REPORT HAZOP

East Coast Grid Expansion MW880 Milne CS HAZOP Typical for MW880 and MW433 New (Stage 1 and 2) Installations on MOOMBA WILTON PIPELINE

Project No		21100			
Document No		21100-RP-R-0002			
Rev	Date	Status	Originated/ Custodian	Checked	Approved
1	13/05/21	Issued for Use			
			R. Fagarasan Principal Mechanical Engineer	C. Button Team Lead-Process & Pipeline Engineering	P. Orangi Team Lead Bid Support

F-5060
LP FUEL GAS COALESCING FILTER
FILTER MEDIA: TBC
DESIGN PRESSURE: FV/1,960 kPag
DESIGN TEMPERATURE: -29/65°C

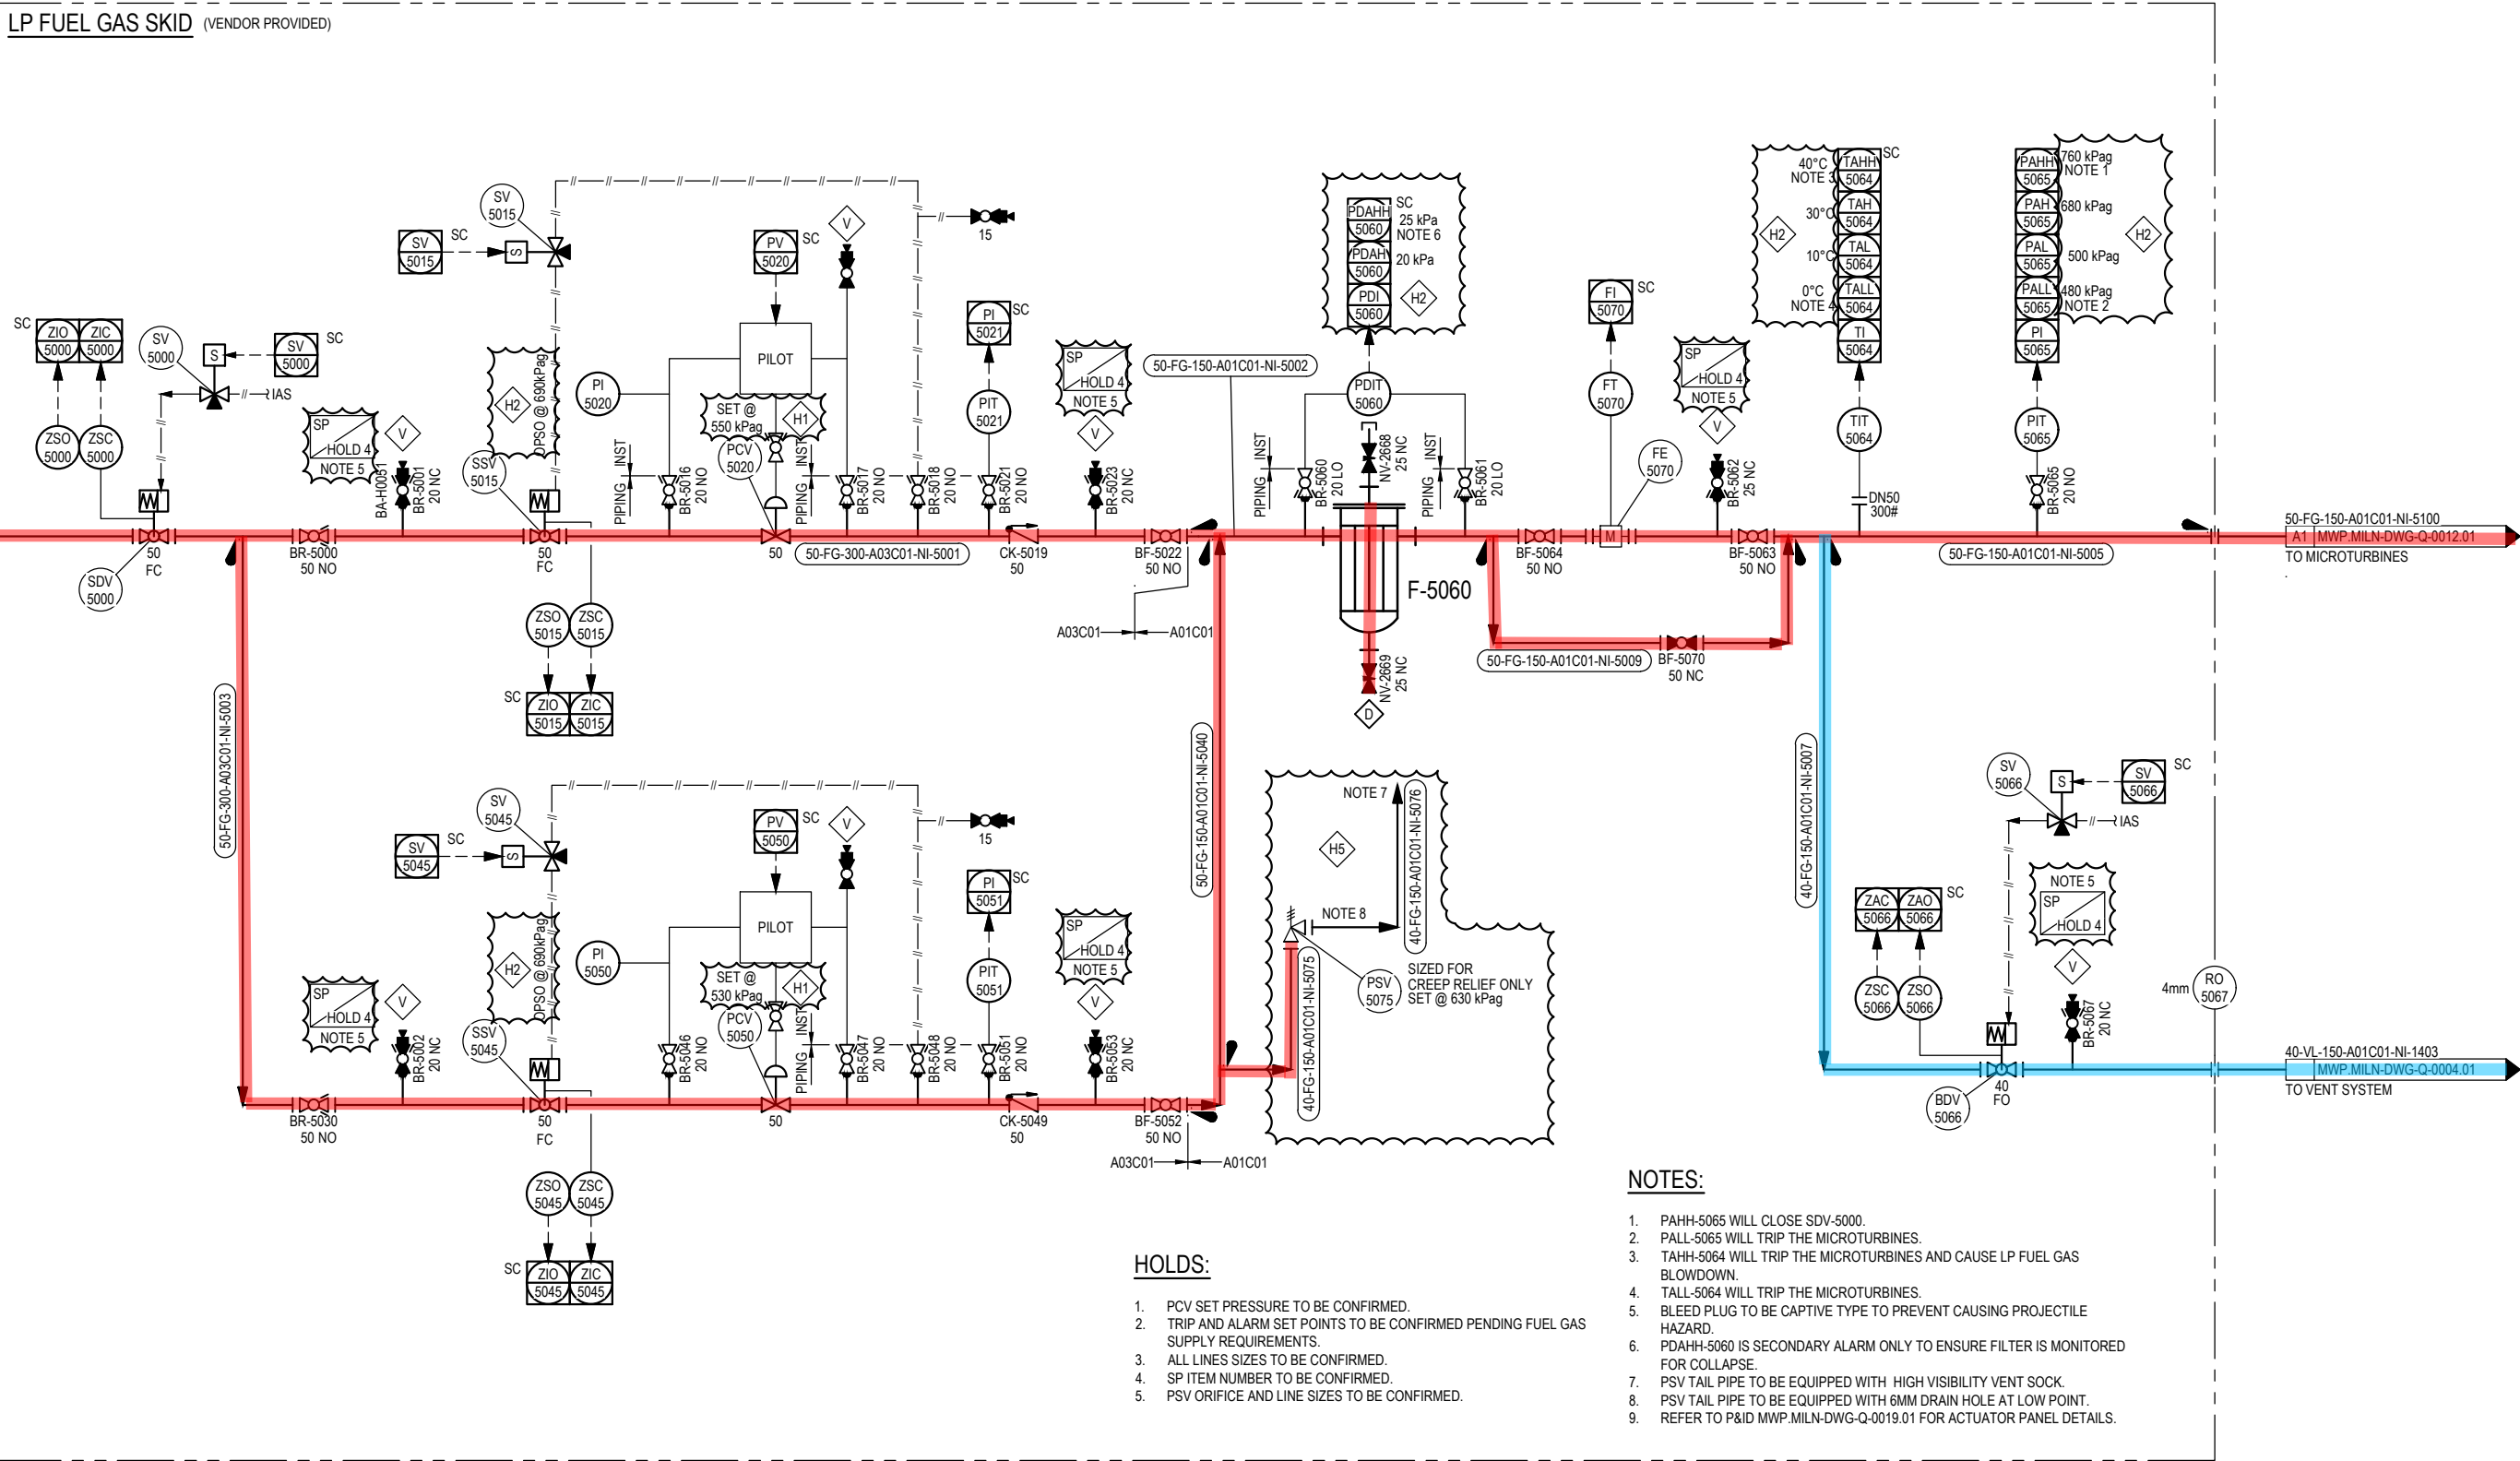
8	High Level	N8-1-7	High liquid level in filter coalescer vessel F-5060	potential liquid carryover into LP fuel gas skid	NONE	Consider the fuel gas take off on PID-Q-0010 reference D6 to be taken from downstream of the filter coalescer F-2685 If changed, show on the PID	JE	86	FEED			
8	Low Flow/Low Level	N8-2-3	Misalignment of valves	AS ABOVE	Valve limit switches on actuated valves	manual valves in the flow path to be provided with lockable tabs	CD	87	FEED			
8	High Pressure	N8-6-2	Failure of the regulators PCV-5020 / PCV-5050 open	High pressure with potential for LOC and ignition and explosion	HAZOP workshop view is that high flow will always result in high pressure due to limited volumes. SSV-5015 and SSV-5045 PAHH-5065	the micro turbine vendor to advise MTM on the required rating for the flexible tubing into the micro turbine and set point for the LP fuel gas regulators slam shuts, PSV and high pressure PAH / PAHH alarms and trips as well as all the set point, alarms and trips for low pressure MTM to show correct set points on PIDs	MP / JE	88	FEED

NODE	GUIDE WORD	ITEM	POSSIBLE CAUSES	CONSEQUENCES	EXISTING SAFEGUARDS	ACTION	ACTION	ACTION	FEED/DD	CLOSE OUT COMMENTS	CLOSE OUT DATE	SIGNATURE
							BY	NO.				
8	General	N8-19-3	thermowell, temperature element, size and rating not shown on the PID on TIT-5064	incorrect depiction of equipment	NONE	show the thermowell, temperature element, size and rating on the PID on TIT-5064 as well as the correct installation detail in 50 NB piping	JE	98	FEED			
8	General	N8-19-4	Thermowell temperature element can be affected by the RO in flow element FE-5070	potential failure of the thermowell due to high stresses	NONE	Provide minimum 6D separation between FE-5070 and TIT-5064 Add note on the PID	JE	99	FEED			
8	General	N8-19-5	Slam shut SSV-5015 or SSV-5045 trips leads to call out on site	potentially unnecessary call out	NONE	Consider whether a remote or automatic reset of slam shut by IOC should be implemented	CB	100	FEED/DD

Action:
Show the thermowell, temperature element, size and rating on the PID on TIT-5064 as well as the correct installation detail in 50 NB piping.

T-1701
WATER STORAGE TANK
SIZE: HOLD 2
CAPACITY: 10,000L

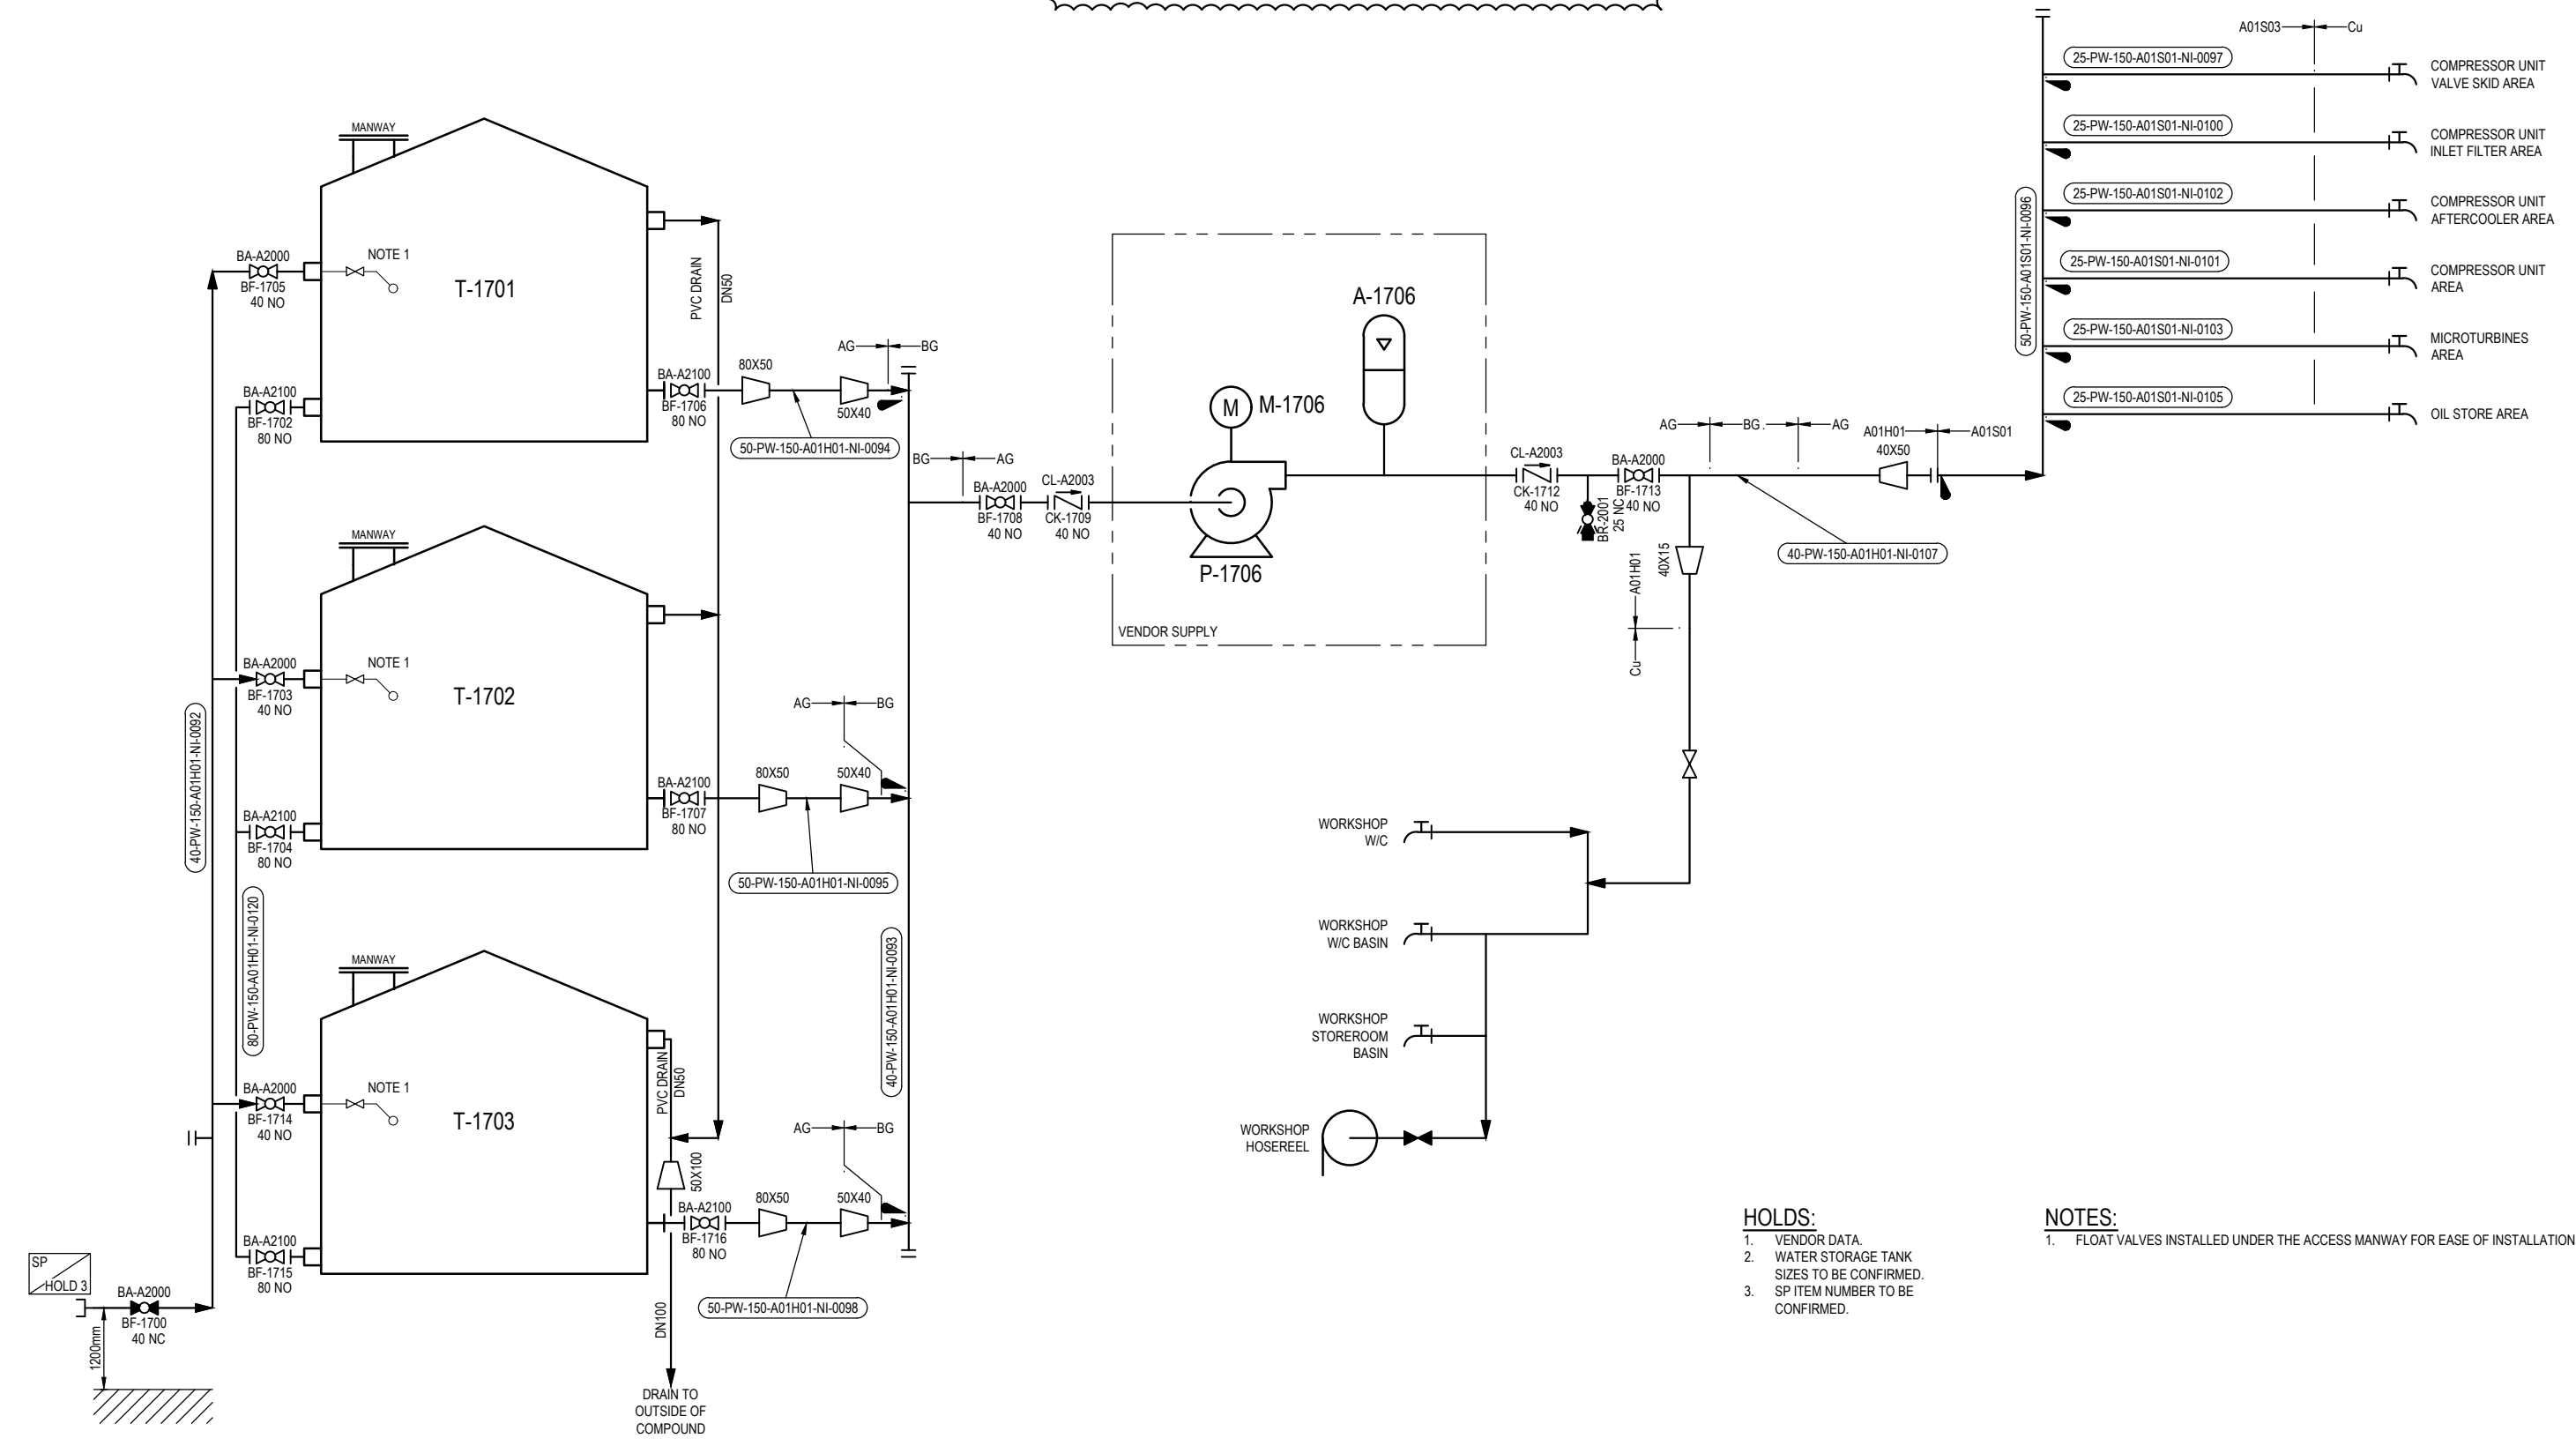
18	Testing Equipment/Product	N18-13-2	insufficient facilities to check water quality for spraying equipment, safety showers etc.	Potential for damage to equipment	NONE	Provide a water testing and dosing (or UV light protection) program for the water used in facilities	PO	120	FEED/DD			
18	Plant Items Operable/Maintainable	N18-14	No significant concern			PID symbology to show pressure switch ON/OFF pump control and tank tank level switch interlock as vendor supply local control as opposed to station control system (tank LALL proposed to be sent to station control system and IOC	JE / MP	121	FEED			
18	General	N18-19-1	Water for personal accommodation not shown on PID	no water to the Accommodation	NONE	Show water to Accommodation as a water consumer on the PID	JE	122	FEED			
18	General	N18-19-2	Water in this system is not potable at this time	Poisoning workers	NONE	Project to identify solutions to provide clean drinking water and water use for kitchen and showers based on a water quality report for the water source on site provide by APA	JE / BC	123	FEED/DD

18	General	N18-19-3	Water in this system is not potable at this time	Poisoning workers	NONE	Project to clearly separate and segregate and tag the potable water outlets / consumers and non-potable water outlets / consumers	JE / BC	124	FEED/DD			
18	General	N18-19-4	Water in this system is not compliant with Solar specification	potential damage to Solar equipment	NONE	Project to confirm water quality requirements from Solar and provide complaint source of water	KM / BC	125	FEED/DD			
18	General	N18-19-5	Safety showers / eye wash stations not shown on this station	inability to shower in case of hazardous liquids spillage	NONE	Project to run risk assessment and identify whether safety showers and eye wash stations are required on this site	PO	126	FEED/DD			
18	General	N18-19-6	Thermal release on safety showers / eye wash stations draining the water out of the station	water not available	NONE	If safety showers / eye wash station are required, design a thermal relief system in such a way that water wastage is not creditable, APA / MTM to provide review of the vendor proposed system	PO	127	FEED/DD

18	General	N18-19-7	No signal to IOC is show in regards to tank level	Inability to remotely alert IOC operators of the low level in T-1701/02/03	NONE	Review the need for tank level to be sent to IOC by SCADA	PO / SH	128	FEED/DD			
Overview 1 - Compressor Utilities												
O1	Temperature	O1-1	Seal gas supply temperature outsourced from downstream of the after cooler and may result in temperature being too low	Potential for dropping liquids and damage to dry gas seals	NONE	Process to provide calculations of the lowest temperature for the dry gas seals and align with Solar's specification, provide additional heating for liquid removal if any hazard of noncompliance has been identified. Alternative seal gas sources may be considered if required	JE / KM	129	DD
